ALLEGHENY COUNTY SANITARY AUTHORITY

CONTRACT NO. 1747

TEMPORARY PRIMARY DISINFECTION

ADDENDUM NO. 1

CHLORINE RESIDUAL METER SCHEMATIC

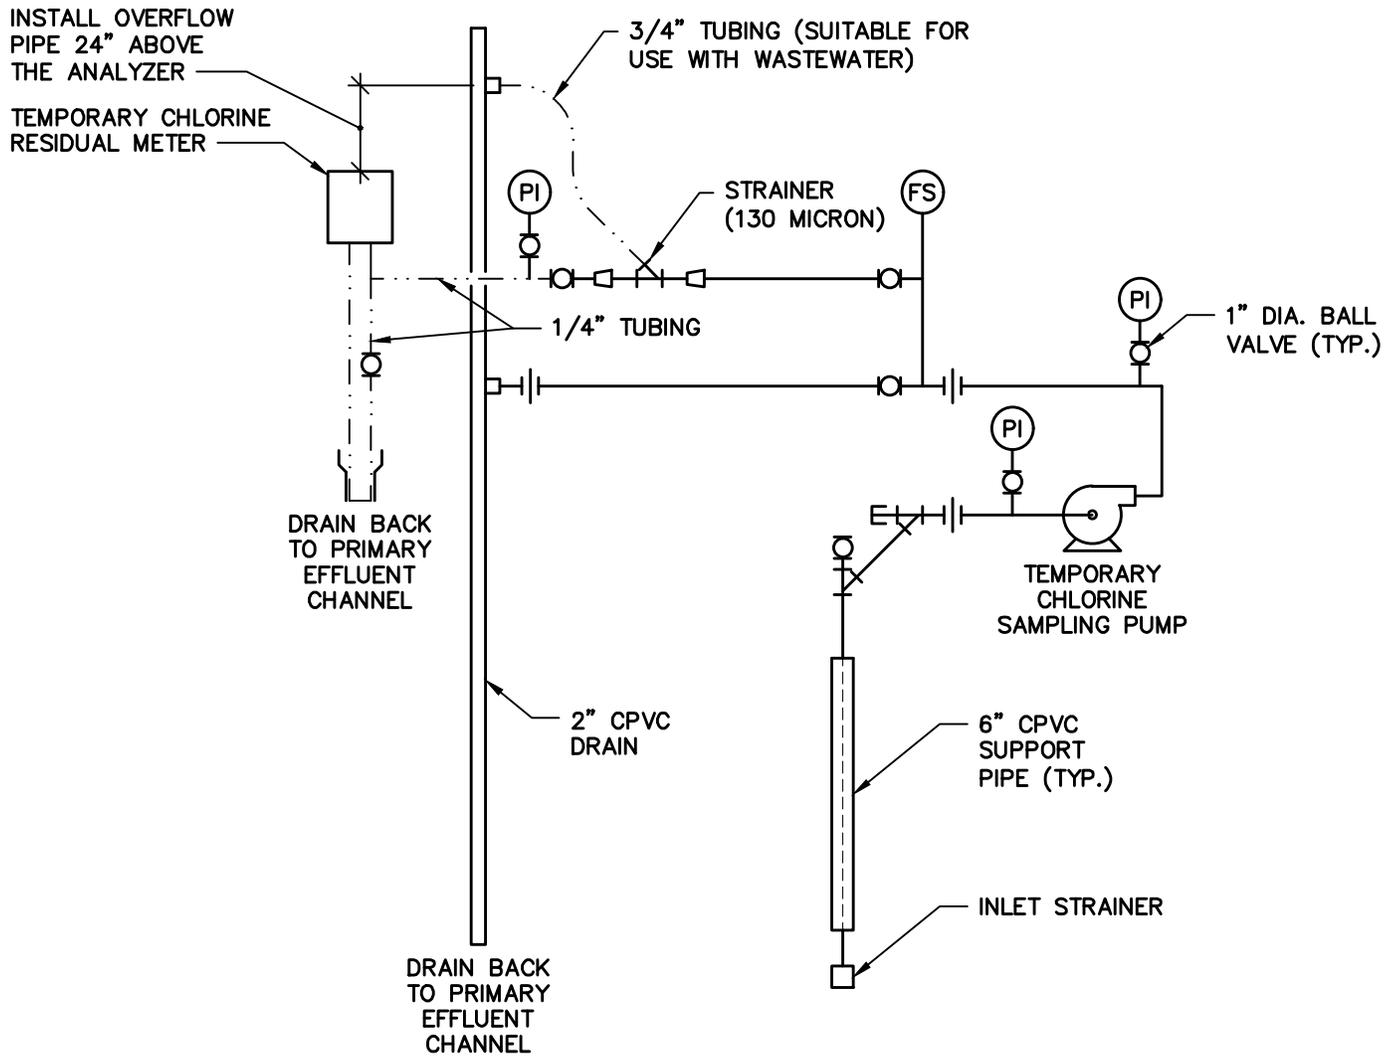
- f) DELETE references to Section A ramp under Item 5.1.B. Only Section B ramp to be provided and installed as shown on Drawing M-8.
- g) ADD Item 8.2, as follows, “8.2 Contractor shall note that the flow rate given in 8.1 above is the maximum flow rate required by the chlorine residual analyzer while normal sample rates are expected to be as noted in Section 7.3. Flow not required for analysis shall be drained through hose or hard-piped back to primary effluent channel as shown on SK-1 (attached).”

- a) ADD attached SK-1, Chlorine Residual Meter Schematic to Drawing M-8.

1. ALL PIPING IS 1" CPVC (SCHEDULE 80) UNLESS OTHERWISE NOTED.

ALLEGHENY COUNTY SANITARY AUTHORITY
WASTEWATER TREATMENT PLANT
TEMPORARY PRIMARY DISINFECTION
M-7
**EFFLUENT FLUSHING WATER AND
CHLORINATION BUILDING SECTIONS.**

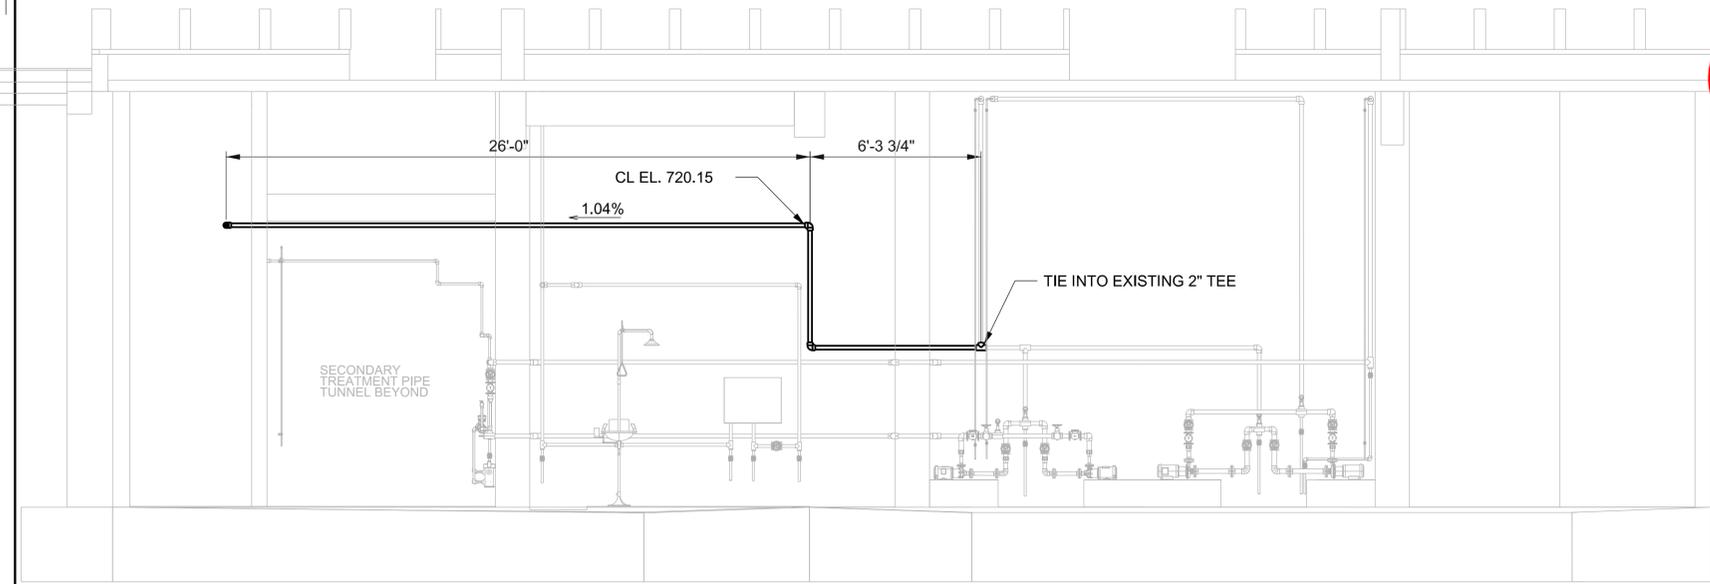
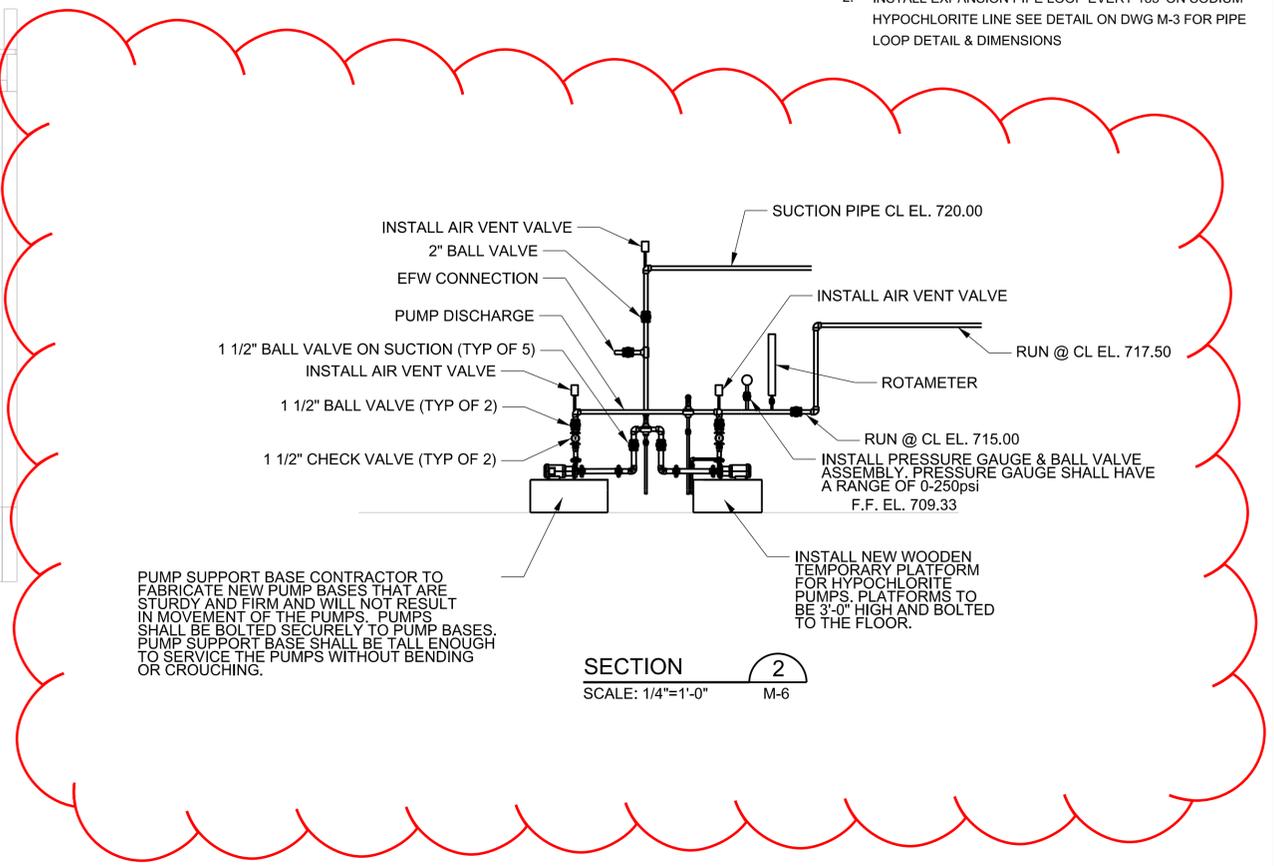
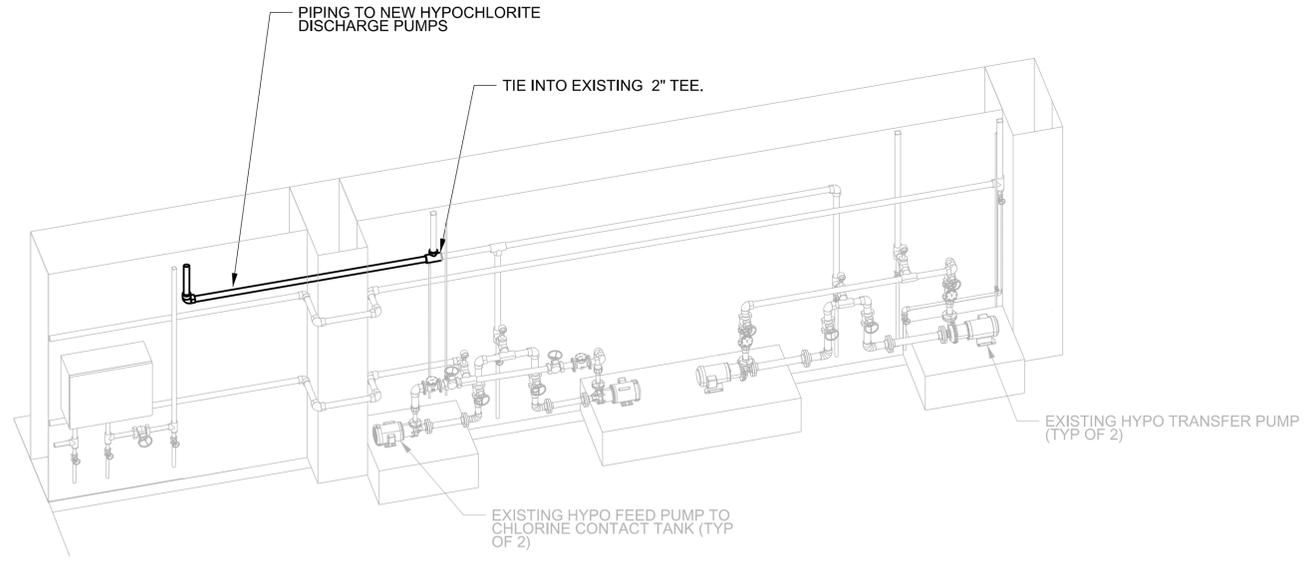
3. Drawing M-7:

- a) REPLACE with attached revised Drawing M-7.

ARLETTA SCOTT WILLIAMS EXECUTIVE DIRECTOR, ALCOGAN		ALLEGHENY COUNTY SANITARY AUTHORITY WASTEWATER TREATMENT PLANT TEMPORARY PRIMARY DISINFECTION		Contract: 1747
M-9 TEMPORARY PRIMARY DISINFECTION PROCESS & INSTRUMENTATION DIAGRAM				CAD File Name: M-9.dgn
				Date: 01 / 2021
				Sheet: 9 OF 14

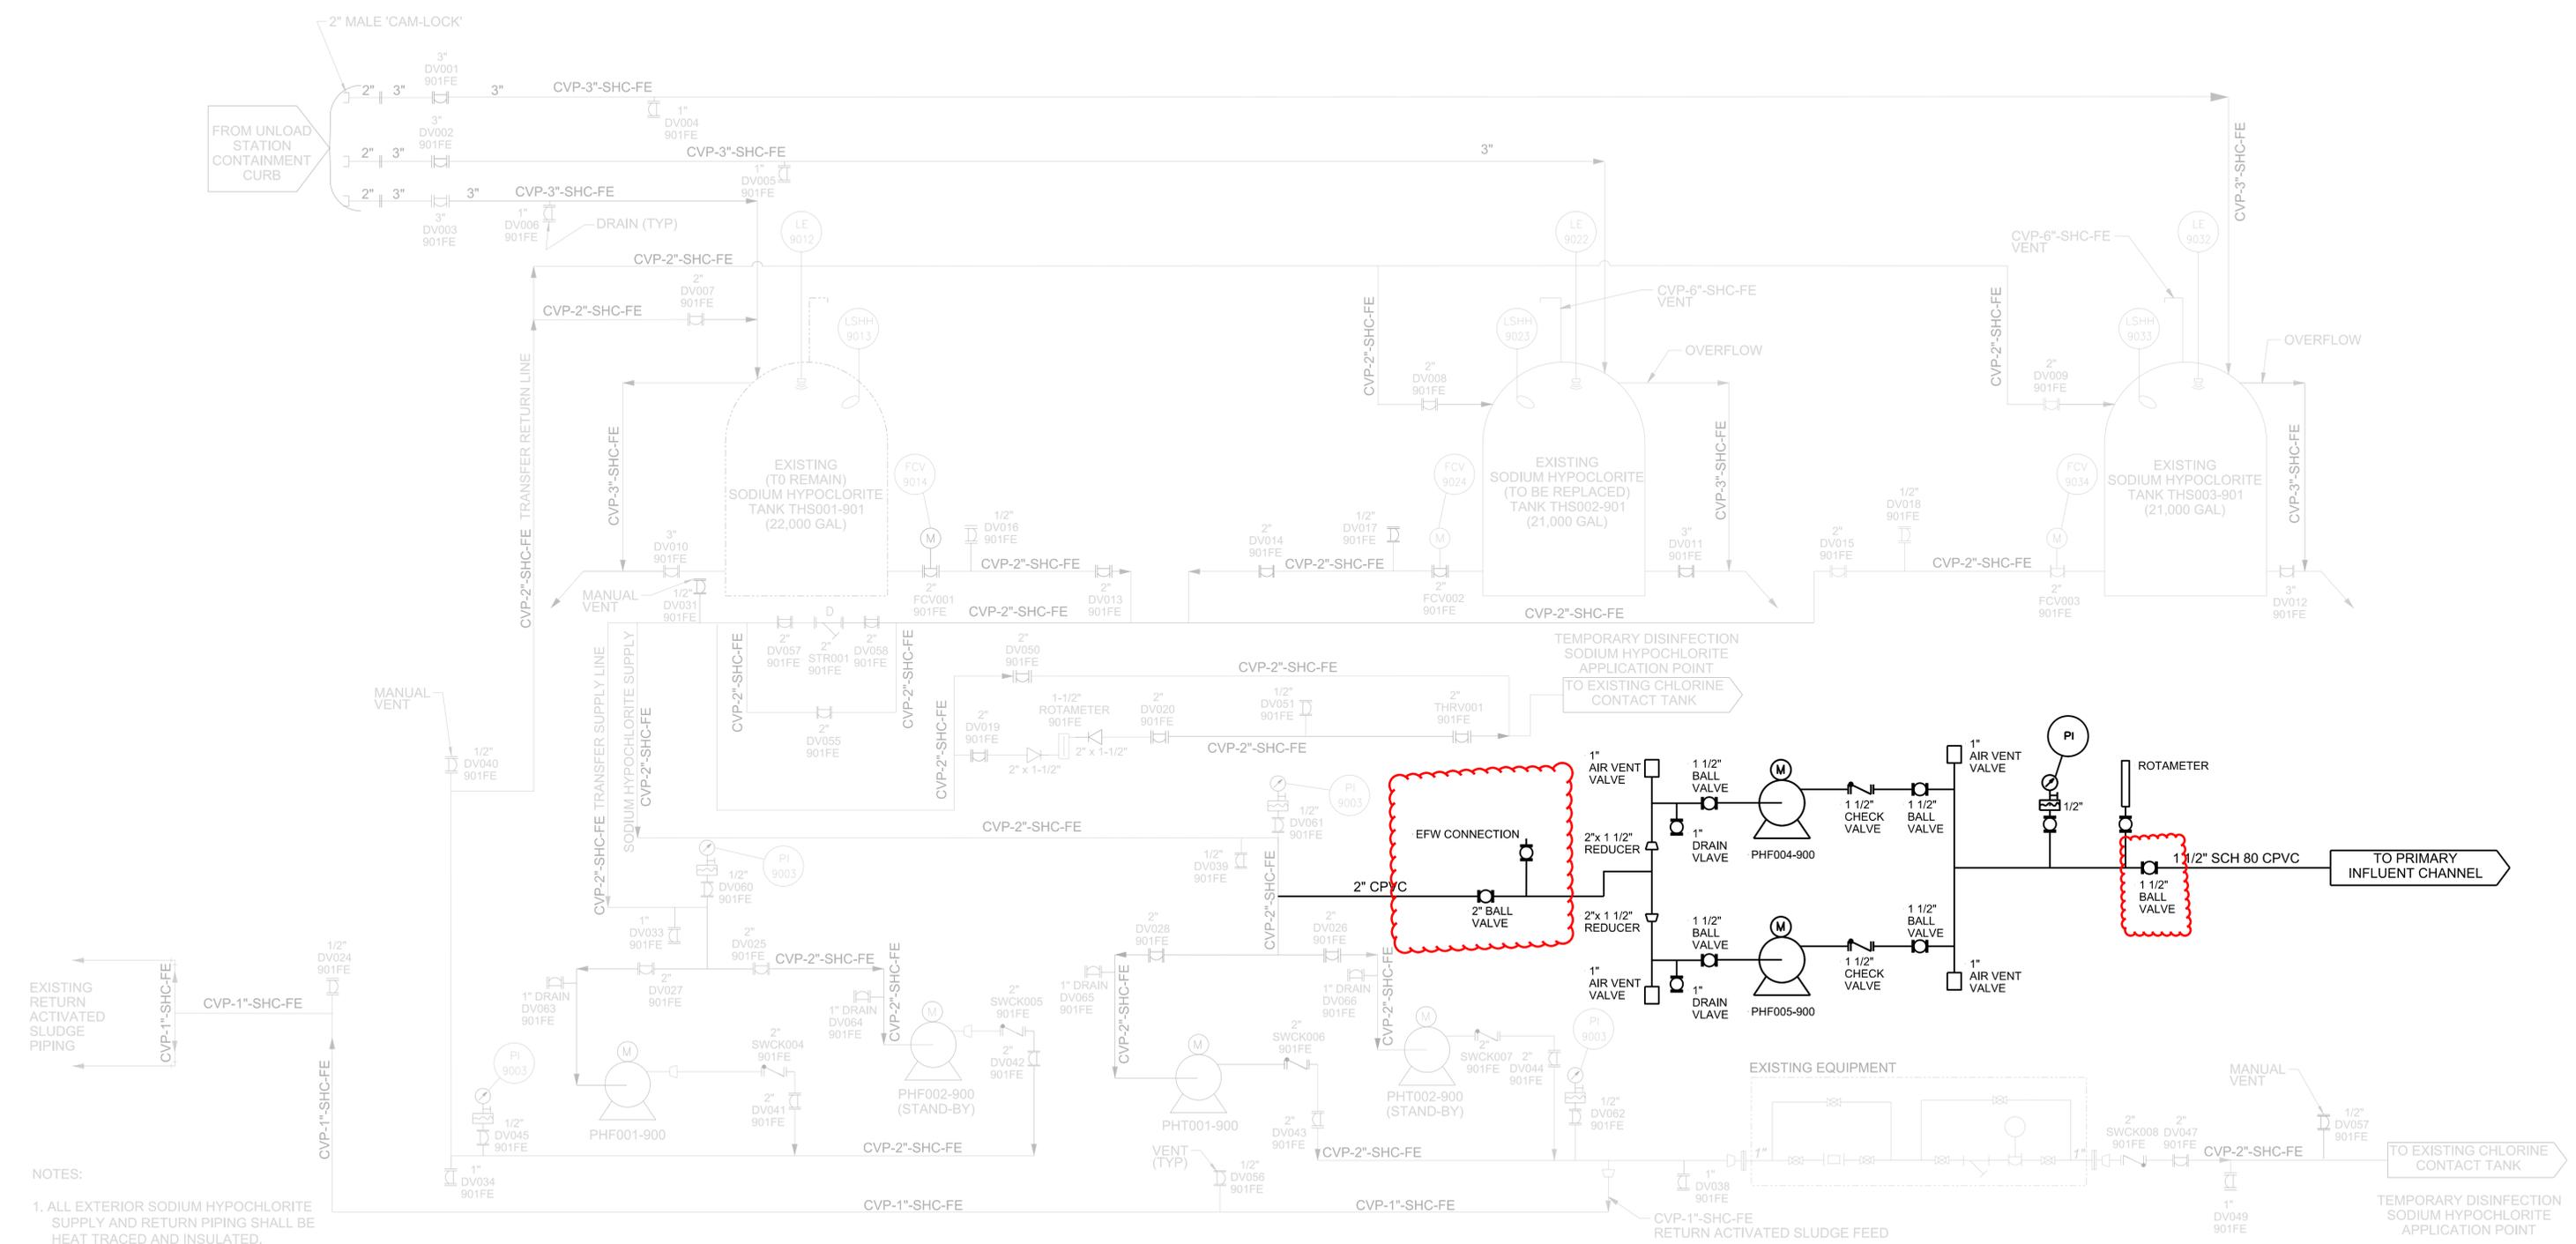
5. Drawing M-9:

- a) REPLACE with attached revised Drawing M-9.
